**FIELD SAFETY CORRECTIVE ACTION FSCA # 2018-04
MANDATORY HARDWARE UPDATE - PLEX ELITE 9000**

The purpose of this letter is to advise you that Carl Zeiss Meditec, Inc. (CZMI) is voluntarily performing a Field Safety Corrective Action on the PLEX® Elite 9000. This action involves a mandatory hardware update that applies to all PLEX Elite 9000 devices.

Figure 1. PLEX Elite 9000 Power Table Up/Down Switch. Avoid any contact with the metal enclosure (including mounting screws) surrounding the black plastic Up/Down switch.

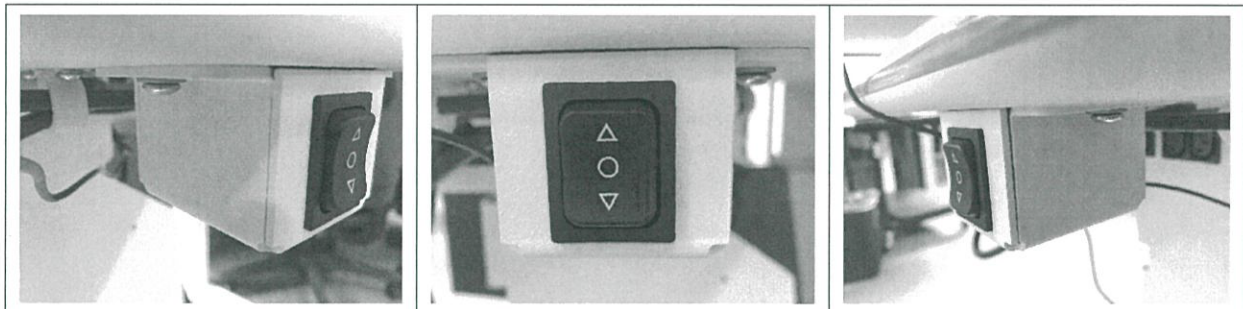
PLEX ELITE 9000 POWER TABLE UP/DOWN SWITCH: Under certain fault conditions, the existing design may expose the operator to a hazardous voltage when contacting the metal enclosure (including mounting screws) around the PLEX Elite 9000 Power Table Up/Down switch. Refer to Figure 1. A hazardous voltage from an electrical short circuit could occur as a result of damaged insulation on one of the wires inside the enclosure for the Power Table Up/Down switch.

- When adjusting the height of the Power Table, touch only the black plastic portion of the Up/Down switch. Avoid any contact with the entire metal enclosure (including mounting screws) surrounding the black plastic Up/Down switch. **Refer to Figure 1.**

To correct the issue, our service staff will contact you to schedule a Field Service Engineer to perform a mandatory hardware update for your PLEX Elite 9000, s/n: XXX

Until the mandatory hardware update has been performed, follow the procedure below in order to continue use of the PLEX Elite 9000:
